City of Woodburn
Community Development Dept.

Memorandum

Date: November 8, 2021
To: Dago Garcia, P.E., City Engineer
Cc: Chris Kerr, AICP, Community Development Director
Craig Larson, PE, Project Engineer, Pacific Community Design
From: Colin Cortes, AICP, CNU-A, Senior Planner *CC*
Subject: **Planning Division review comments on original submittal October 18 of civil engineering plans for Dove Landing PUD (ANX 2020-03)**

Planning Division staff identifies revisions needed before sign-off on Public Works Department Engineering Division approval and issuance of civil engineering plans for the Dove Landing planned unit development (PUD; ANX 2020-03) along the west side of Boones Ferry Road NE.

Exhibit S Conceptual Alignment of ADA transitions and landing area / sidewalk

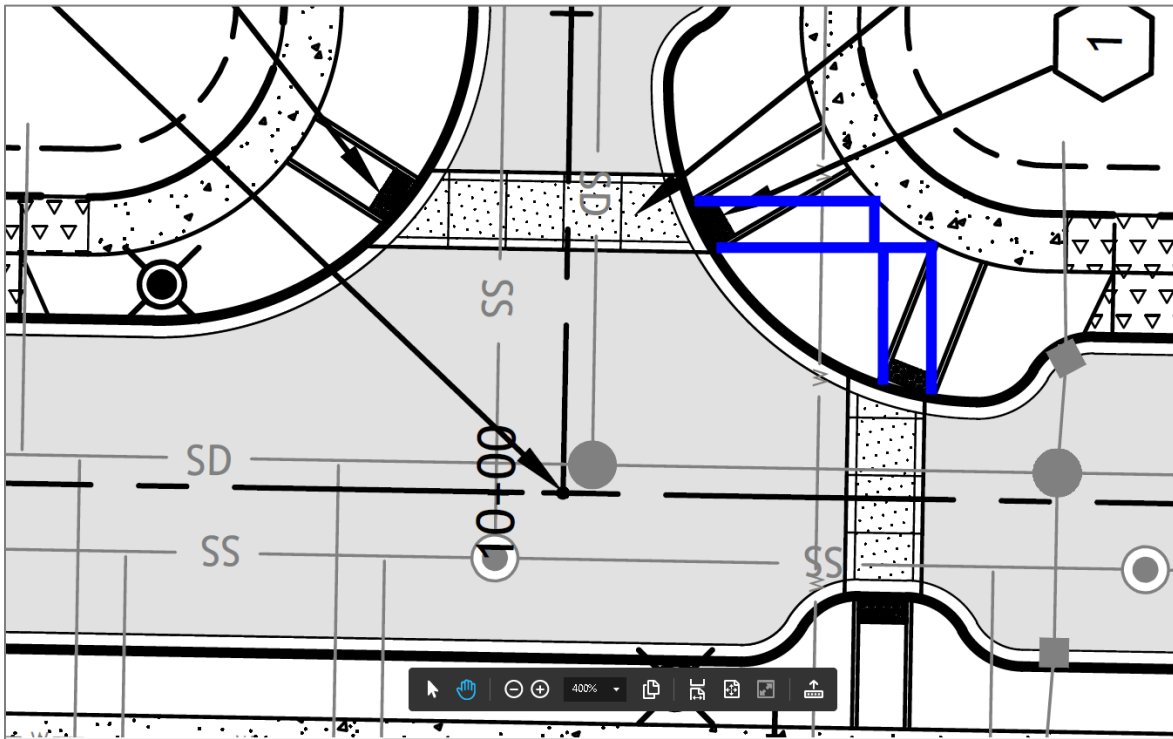
4. Demonstrate conformance with Attachment 203 Part B6.
- S. Owl Avenue & Dove Street NE corner: Straighten the curb ramps relative to sidewalks so that there’s no or almost no out-of-direction travel between west and south curb ramps. (This may lead to widening of corner sidewalk towards the southwest.) Revise Sheets 209 & CR3. See the exhibit below.

SITE PLAN (WEST)

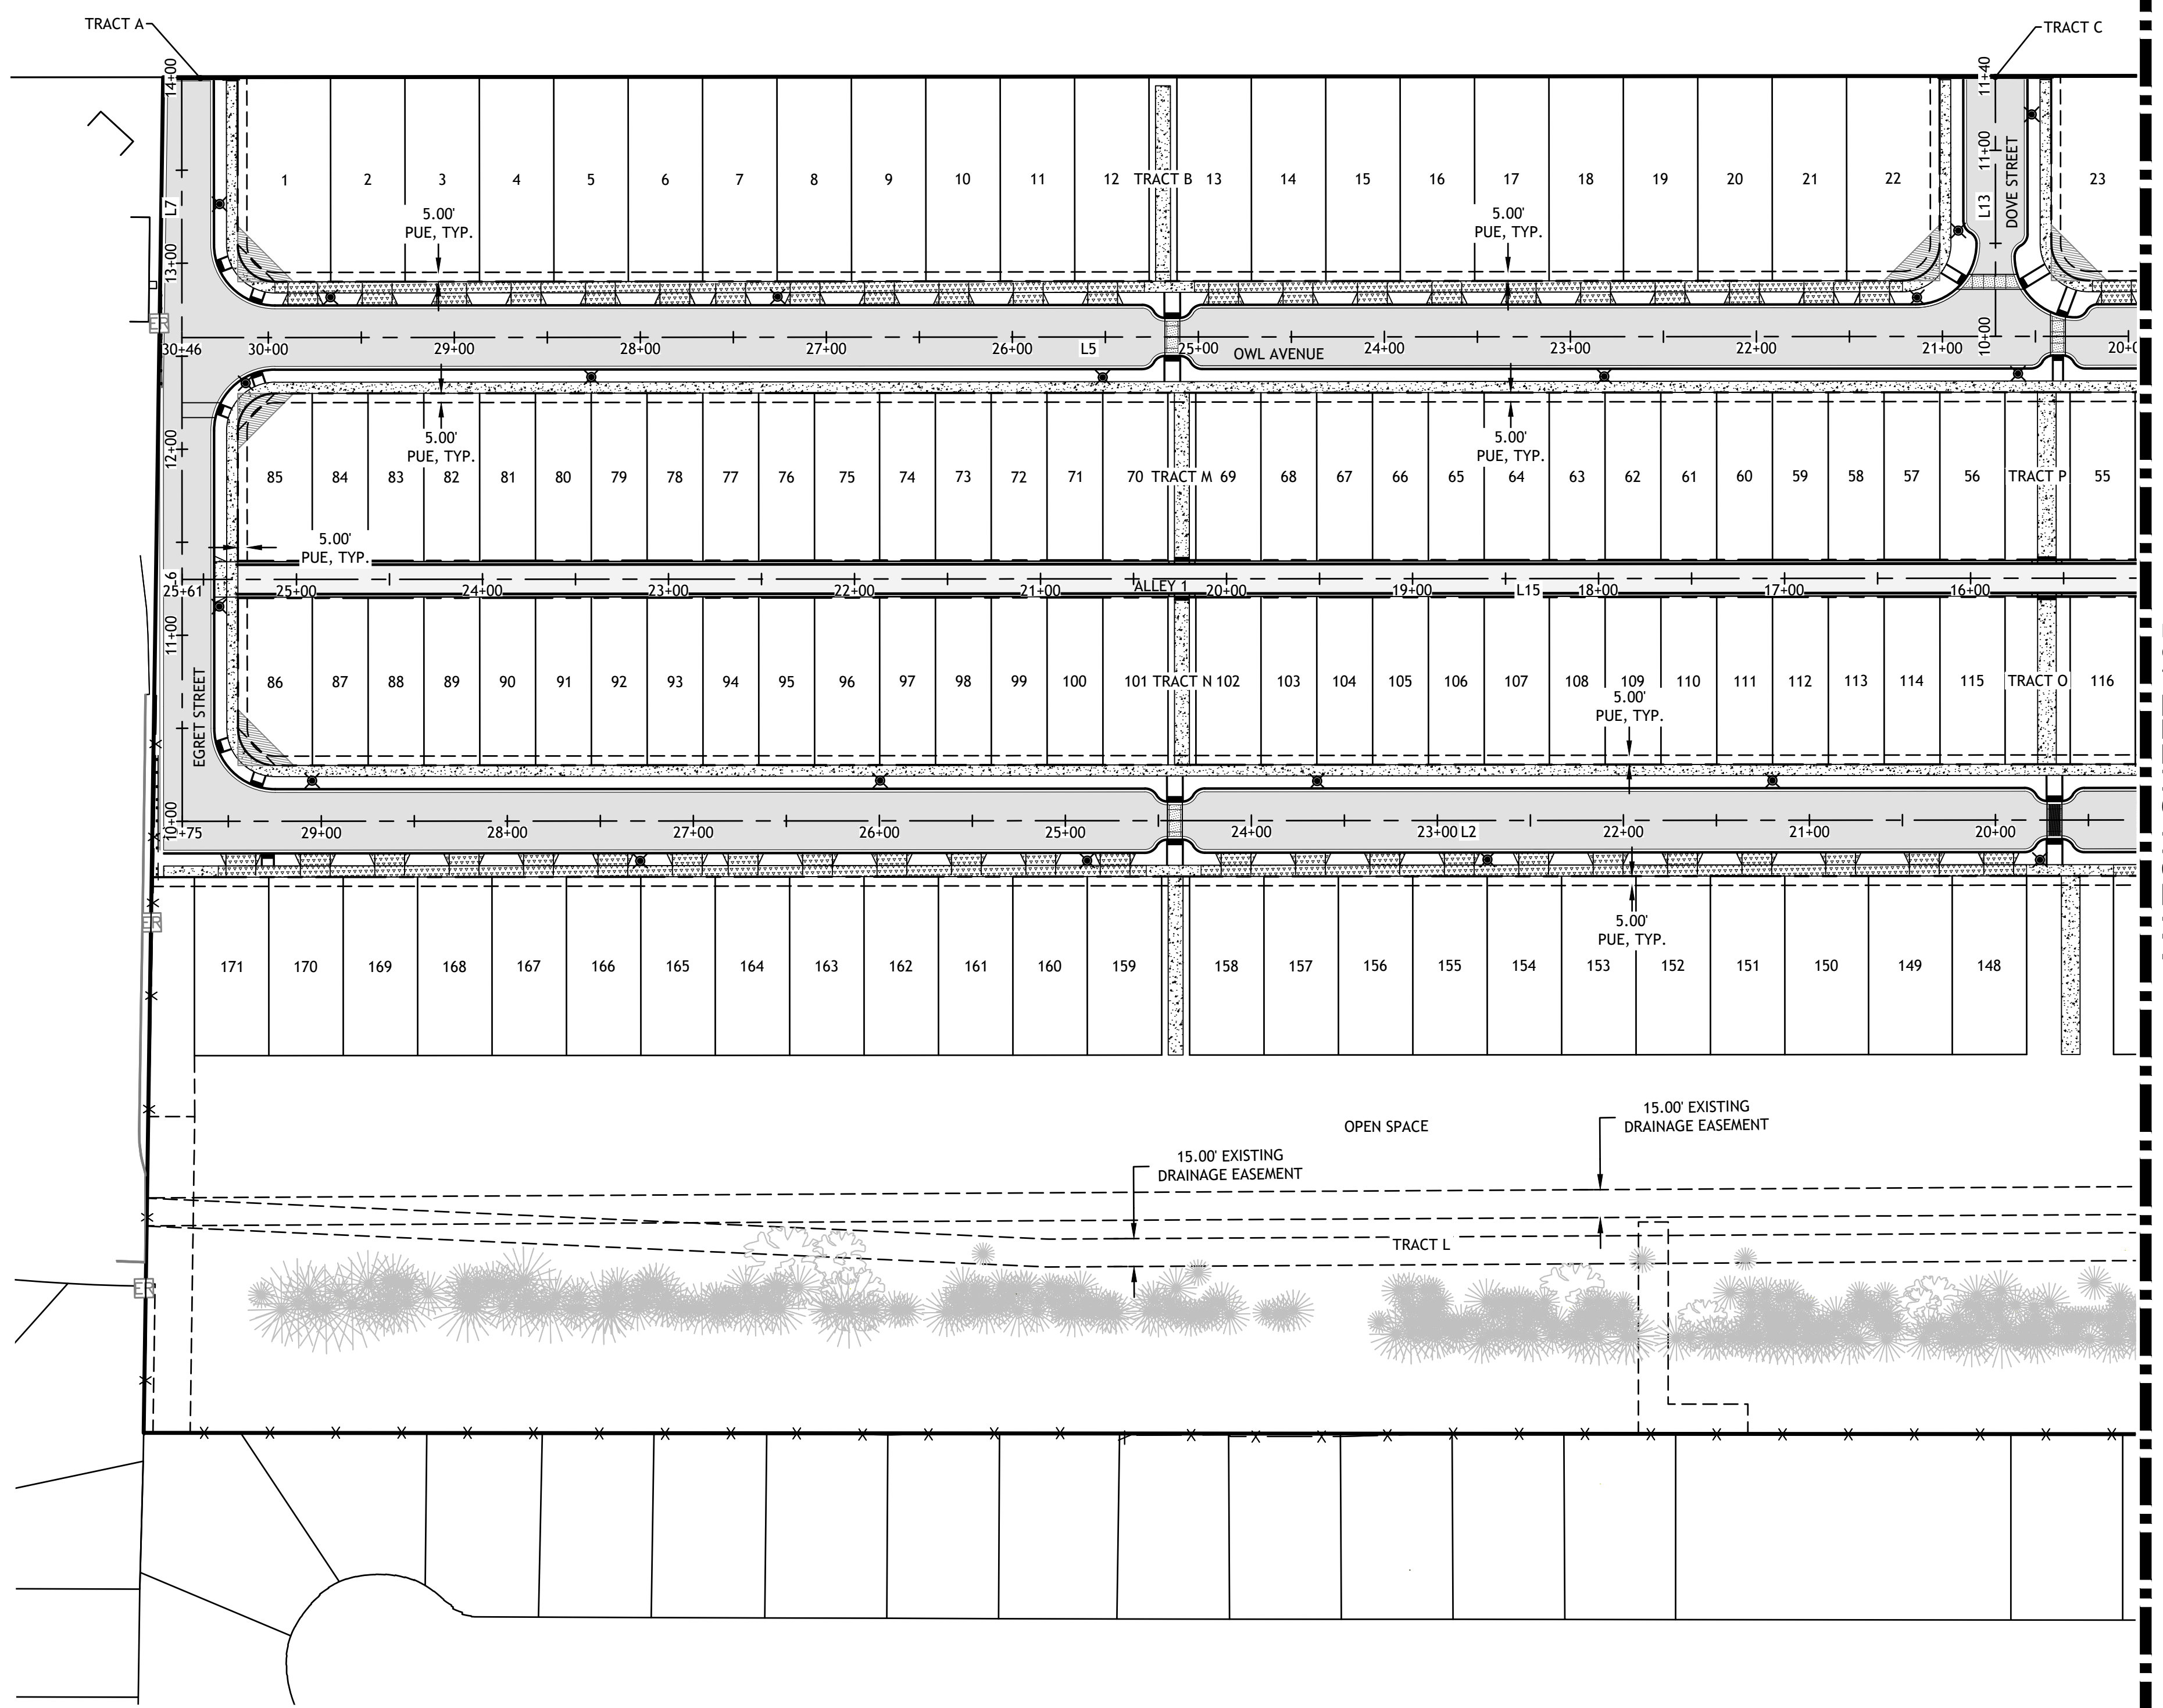
- O. Street tracts: Remove all and replace with ROW as follows:
1. Tract A: Remove Tract A and have Egret Street ROW extend to the north subdivision boundary. Revise Sheet 104 and any other sheets that delineate or label it.

2. Tract C: Remove Tract C and have Dove Street ROW extend to the north subdivision boundary. Revise Sheet 104 and any other sheets that delineate or label it.

1. Tract B:
 - a. Extend the bike/ped path up to the north subdivision boundary. Revise Sheets 104, F1, and any other sheet that shows it.
 - b. Based on Attachment 203 Part C2 ("furniture zone"), shift the path to be 2 ft from the east tract boundary and 5 ft from the west. Revise Sheet 104, Sheet F1 plan and cross section E views, and any other sheet that shows it.

4. Tract L middle east spur:
 - a. Shift the path to be 8 ft from west boundary per Attachment 203 Part C2. Revise Sheet 104, Sheet F5 plan and cross section E1 view, and any other sheet that shows it.

5. Tract L middle west spur:
 - a. Shift the path to be 5 ft from west boundary and 2 ft from the east. Revise Sheet 104, Sheet F4 plan and cross section E view, and any other sheet that shows it.

**SITE PLAN
(EAST)**

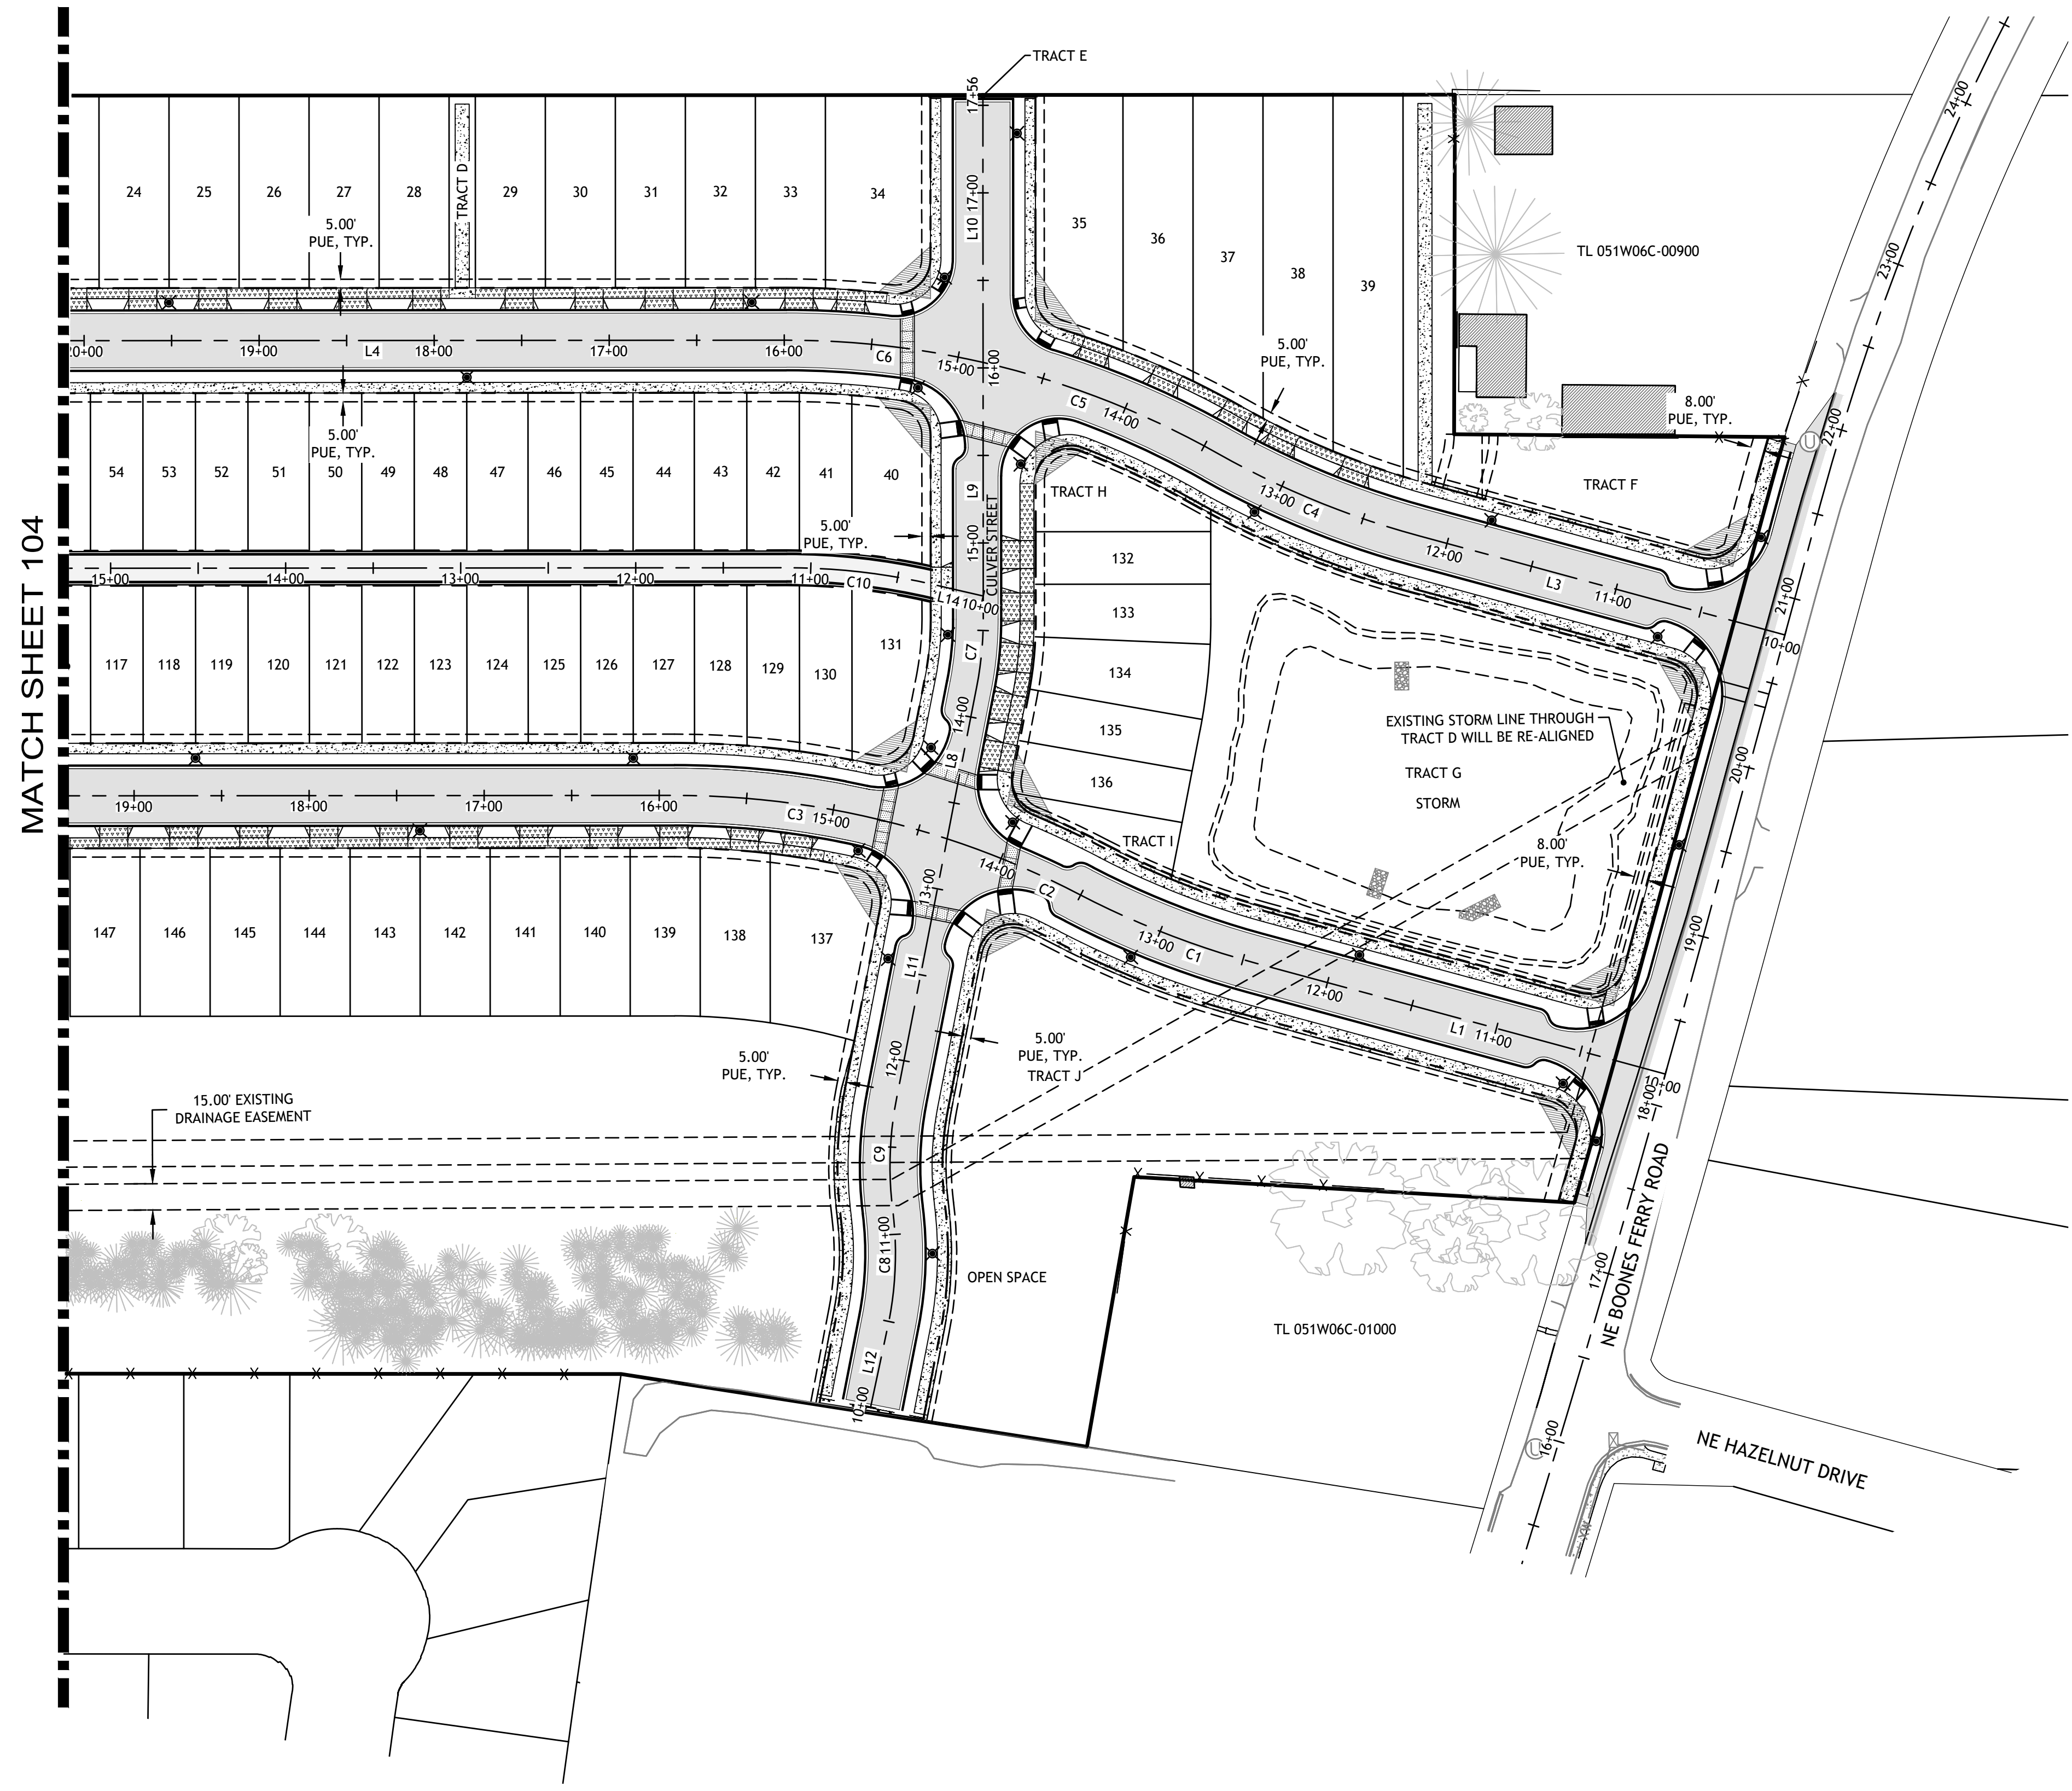
3. Tract E: Remove Tract E and have Culver Street ROW extend to the north subdivision boundary. Revise Sheet 105 and any other sheets that delineate or label it.

4. Tract J: Remove Tract J and have Culver Street ROW extend to the south subdivision boundary. Revise Sheet 105 and any other sheets that delineate or label it.

- c. Because the above item b. leaves too little width for east side trees, revise Sheet L2.01 to remove them.
2. Tract D:
 - a. Extend the bike/ped path up to the north subdivision boundary. Revise Sheets 105, F2, and any other sheet that shows it.

- b. Based on Attachment 203 Part C2 ("furniture zone"), shift the path to be 2 ft from the east tract boundary and 5 ft from the west. Revise Sheet 105, Sheet F2 plan and cross section E views, and any other sheet that shows it.

3. Tract F:
 - a. Extend the bike/ped path up to the north subdivision boundary. Revise Sheets 105, F3, and any other sheet that shows it.
 - b. The Sheet F3 cross section E view seems incorrect compared to the plan view; revise.

6. Tract M:
 - a. Based on Attachment 203 Part C2 (“furniture zone”), shift the path to be 2 ft from the east tract boundary and 5 ft from the west. Revise Sheet 105, Sheet F2 plan and cross section E views, and any other sheet that shows it.

- b. Because the above item leaves too little width for east side trees, revise Sheet L2.01 to remove them.
 7. Tract N:
 - a. Based on Attachment 203 Part C2 (“furniture zone”), shift the path to be 2 ft from the east tract boundary and 5 ft from the west. Revise Sheet 105, Sheet F2 plan and cross section E views, and any other sheet that shows it.
